## ArevaEPRDCPEm Resource

**From:** KOWALSKI David J (AREVA NP INC)  
**Sent:** Monday, June 21, 2010 8:23 AM  
**To:** BRYAN Martin (EXT)  
**Cc:** GARDNER George Darrell (AREVA NP INC); BALLARD Robert W (AREVA NP INC); CONNELL Kevin J (AREVA NP INC); HUDDLESTON Stephen C (AREVA NP INC); BROUGHTON JR Ronnie T (AREVA NP INC); HARTSELL Jody M (AREVA NP INC); EDWARDS Harold E (AREVA NP INC); SLOAN Sandra M (AREVA NP INC); MCINTYRE Brian (AREVA NP INC)  
**Subject:** DRAFT RESPONSES FOR FSAR Chapter 9 Weekly NRC Telecon  
**Importance:** High

Please transmit to Getachew Tesfaye the attached partial set of DRAFT responses to RAI 361 and 417 questions. These responses will be discussed at tomorrow's (6/22/10) FSAR Chapter 9 Weekly Telecon/GoToMeeting with the NRC.

## 9.2.8 Safety Chilled Water System

Figure 9.2.8-1—Safety Chilled Water System Diagram  
Sheet 2 of 4

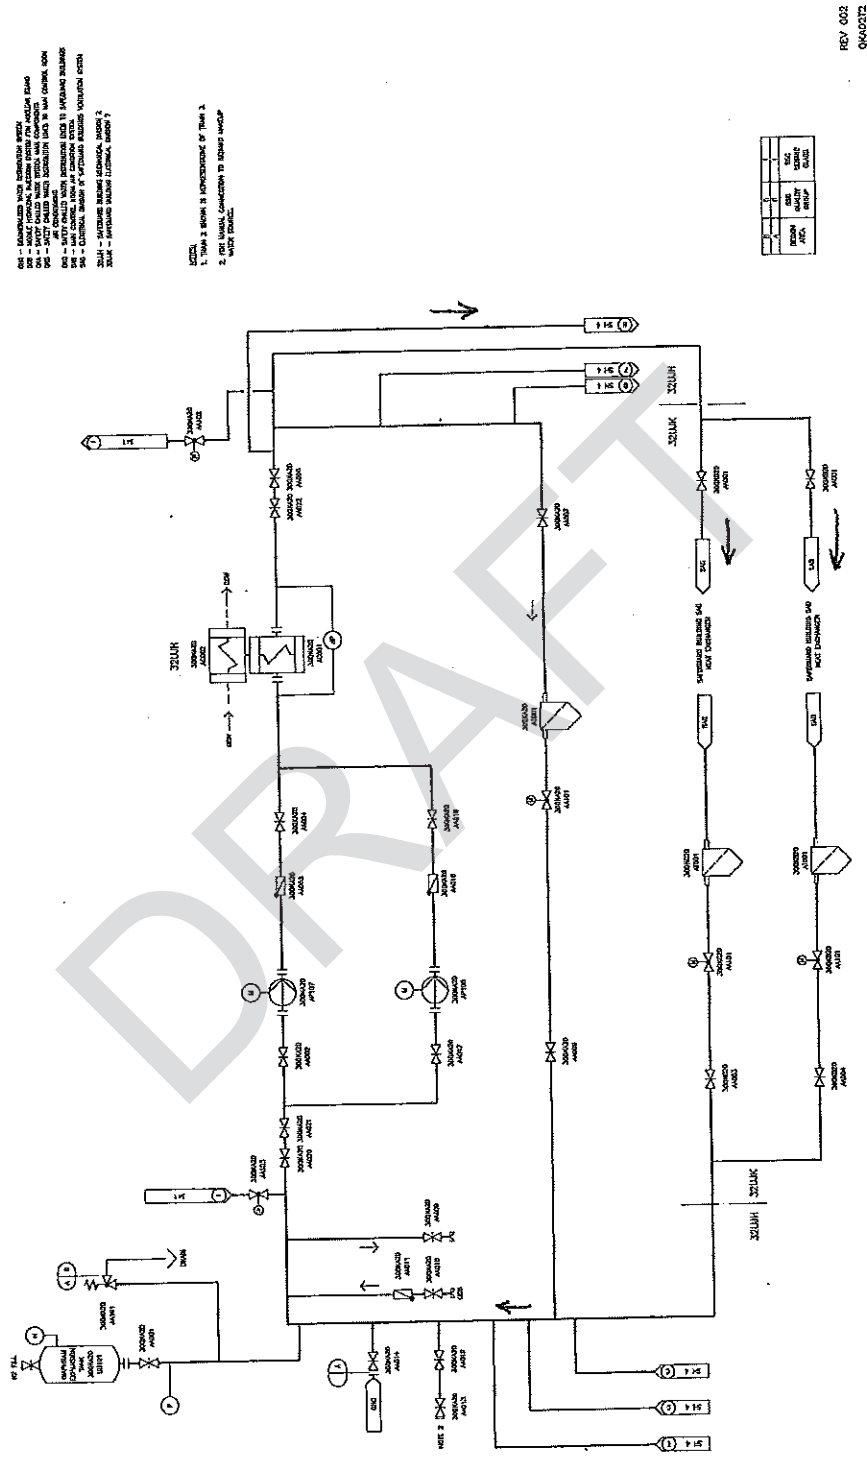
- a. The staff noted that Tier 1 Table 2.7.2-2, "Safety Chilled Water System Equipment I&C and Electrical Design," identifies normal and alternate power supplies for the motor-operated SCWS cross-tie valves, but the valve power supplies are not described anywhere in the proposed Tier 2 FSAR sections provided in the response.
- b. Provide a description of these power supplies in the Tier 2 portion of the FSAR.
- c. Update FSAR Table 3.9.6-2, "In-service Valve Testing Program Requirements" to include the motor-operated cross-tie valves.
- d. Add the SCWS flow direction arrows to the Figure 9.2.8-1 (Sheets 1 through 4), "Safety Chilled Water Diagram," to confirm the directional flows in various sections of pipe under both independent and cross-tie alignments.

Revision 2—Interim  
Revised IAW RAI 361, Q 09.02.02 ~ 95d

- b. See above response.
- c. Refer to response to RAI 356, Question 09.02.02-91 concerning the addition of cross-tie valves to FSAR Table 3.9.6-2.
- d. Refer to response to RAI 174 Supplement 5, Question 09.02.02-53, markup Figure 9.2.8-1 (Sheets 1 through 4). Flow direction arrows will be added where needed. The sheet-to-sheet continuation arrows provide an indication of flow direction. On sheets 1 through 4, the supply side is on the right and the return side is on the left. For cross-tie operation, flow can be in either direction in the cross-tie lines depending on which SCWS train is in operation. For example if SCWS Train 1 is the operating train in divisional pair 1 & 2, starting on sheet 1, approximately half the total flow is through Train 1 cross-tie supply valve 30QKA10AA102 (continuation to sheet 2) then through Train 2 cross-tie supply valve 30QKA20AA102, and then to Division 2 user heat exchangers. Similarly, on the return side, starting on Sheet 2, return flow is from the Division 2 user heat exchangers through the Train 2 cross-tie return valve 30QKA20AA103 (continuation to

sheet 1) then through Train 1 cross-tie return valve 30QKA10AA103 and then to the suction side of the Train 1 pumps. As shown on sheet 1, on the supply side, the other approximate half of the total flow goes to the Division 1 user heat exchangers and returns to the suction side of the Train 1 pumps.

- a. U.S. EPR FSAR Tier 2, Section 9.2.8.3.2 will be revised as described in the response and indicated in the attached markup.
- b. See a. above.
- c. Refer to response to RAI 356, Question 09.02.02-91.
- d. U.S. EPR FSAR Tier 2, Figure 9.2.8-1 (Sheet 2) will be revised as described in the response and indicated in the attached markup.
